Subject: Supply of Equipment for Hydro Power Stations Communication and SCADA System Bid – SAMEPC 11/2018

Addendum No. 2

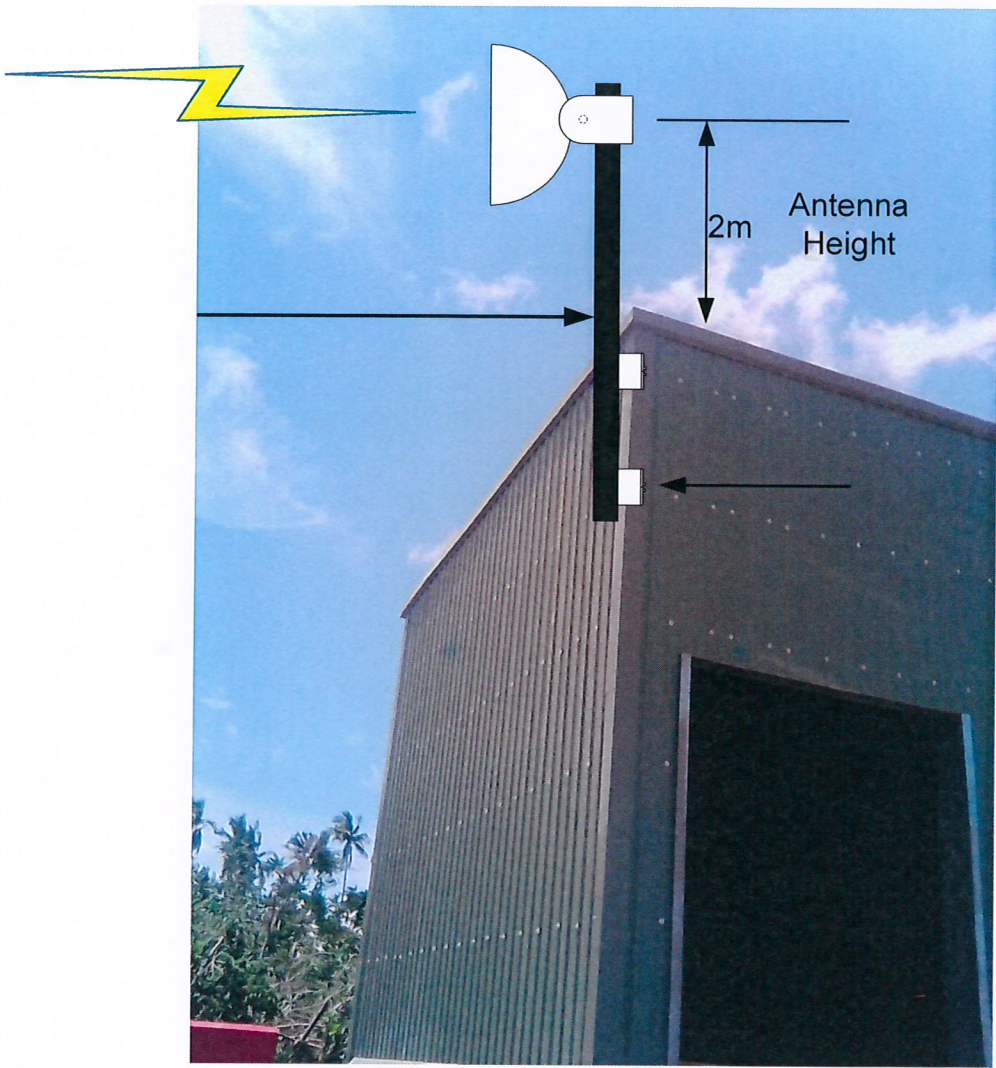
1. This serves to inform all bidders that the Closing date for all bids has changed. The new closing date and time is Monday 9th April 2018, at 10am.
2. Bidders must supply mountings and galvanized poles to mount the antennas at Tafitoala and Vailoa Hydro sites. The pole must be bolted to the side of the building using fabricated brackets or alternative to secure the pole/antenna. Height of antenna from the roof of Tafitoala building must be at least 2m, for Vailoa Building it must be at least 3m. Refer schematic drawing for details.
